## **Former Stag Brewery, Lower Richmond Road, Mortlake, London**

### **Responses to Consultee Comments - Merged**

*In relation to Planning Application refs: 22/0900/OUT (Application A) and 22/0902/FUL (Application B).*

Figure A1: Unadjusted Modelled versus Monitored Annual Mean Roadside NO<sub>x</sub> at the Monitoring Sites (µg/m<sup>3</sup>)

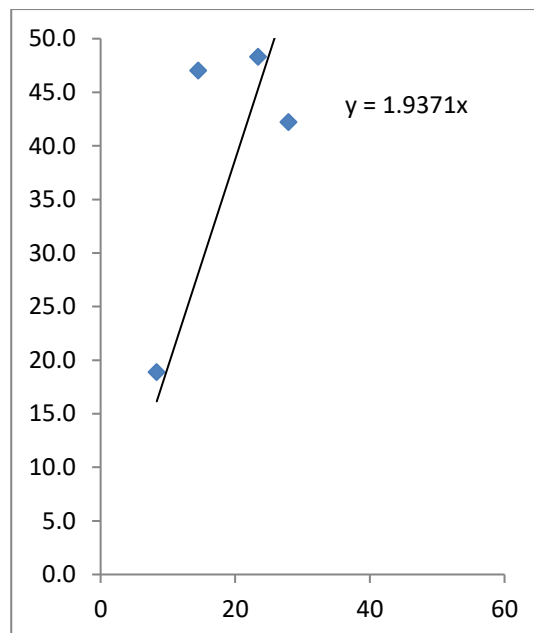
94. No tabulation of the eastings and northings nor mapping of locations were provided - Figure A1 is missing). Accurate location details (eastings/northings) are crucial to calculate exposure at the façade.

95. Please see response to 6.3 above for locations of the monitoring sites. Figure A1 should have been provided previously and is now provided.
